Technical Service Bulletin: tsb101486

Released Date: 24-Aug-2004

New Lubricating Oil Transfer Tube and Oil Transfer Connection

Figure 1

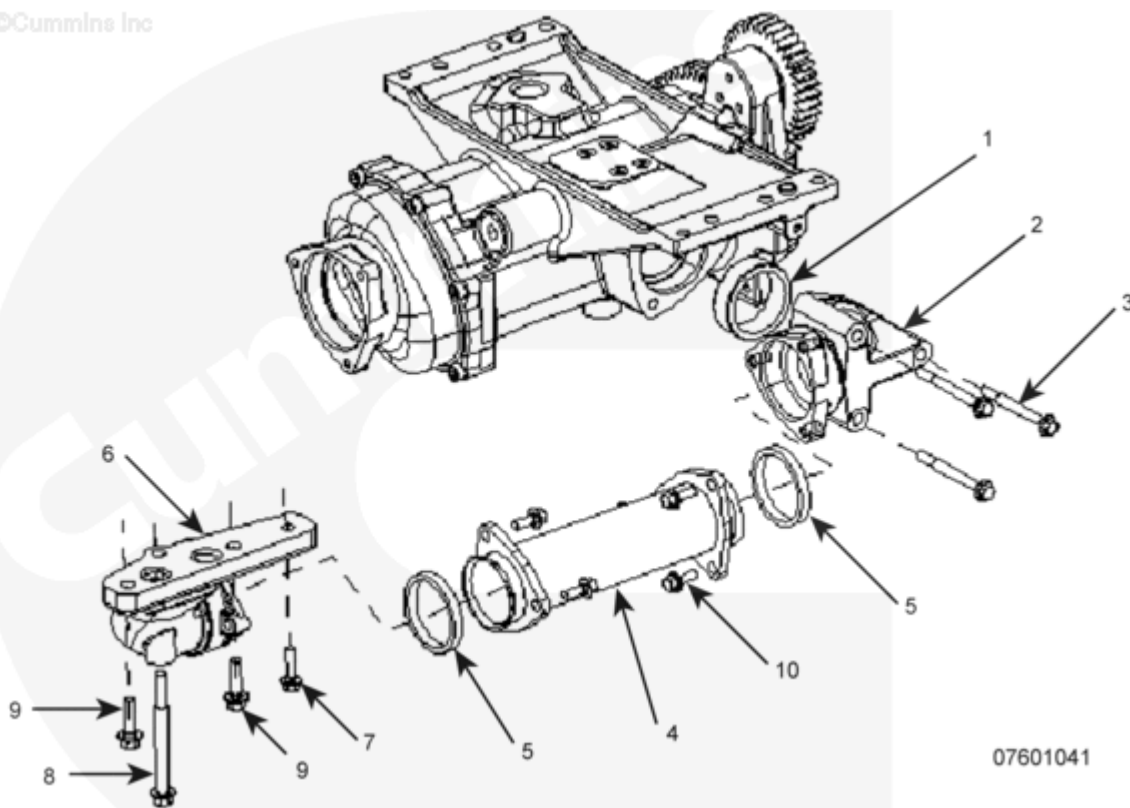
This Service/Parts Topic is to introduce a revised lubricating oil pump discharge tube and oil transfer connection. The new discharge tube and connections have been introduced to improve durability of the system components. The new arrangement is only compatible with those engines that have lubricating oil pumps, Part Number 4100711 for the QSK60, and Part Number 4100710 for the QSK45, and can be used as a direct replacement. Engines that have lubricating oil pump part numbers different to those above remain unaffected and no action is required as a result of this topic. The new arrangement went into production at the Daventry Engine Plant on 8th of March 2004. The ESN first was 33156055.

The revised arrangement consists of a connection elbow fixed to the discharge port of the lube pump, a straight discharge tube and another connection fixed to the engine block. The lubricating oil pump remains unchanged, QSK 60 (Part Number 4100711), and QSK 45 (Part Number 4100710).

Table 1 below, lists the parts that **must** be ordered when fitting the new components on QSK45/60 engines.

S-Shape Type

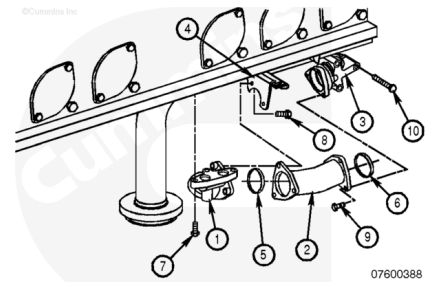
Fitted to lubricating oil pump part numbers:

Arrangement consists of lubricating oil pump connection (3) and block connection (1), with a steel tube (2) bridging the connections (1) and (3).

Connection (1) has three mounting capscrews. Steel tube has slight bend in its section.

Elbow Type

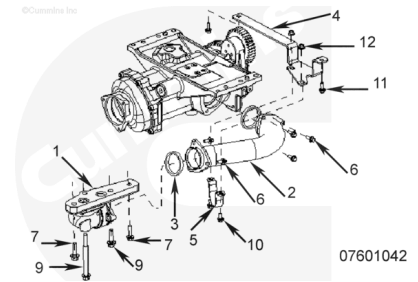
Fitted to lubricating oil pump part numbers:

Arrangement consists of block connection (1), with a steel tube (2) which bridges from block connections (1) directly to lubricating oil pump. Transfer tube bracing is also present.

Straight Type

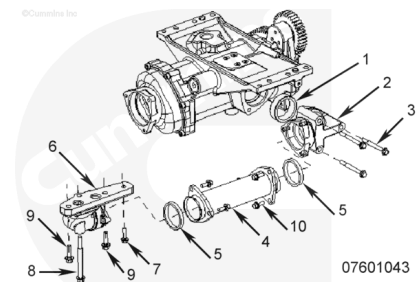
Arrangement consists of lubricating oil pump connection (2) and block connection (6), with a steel tube (4) bridging the connections (2) and (6).

Connection (6) has four mounting capscrews. Steel tube is straight in section.
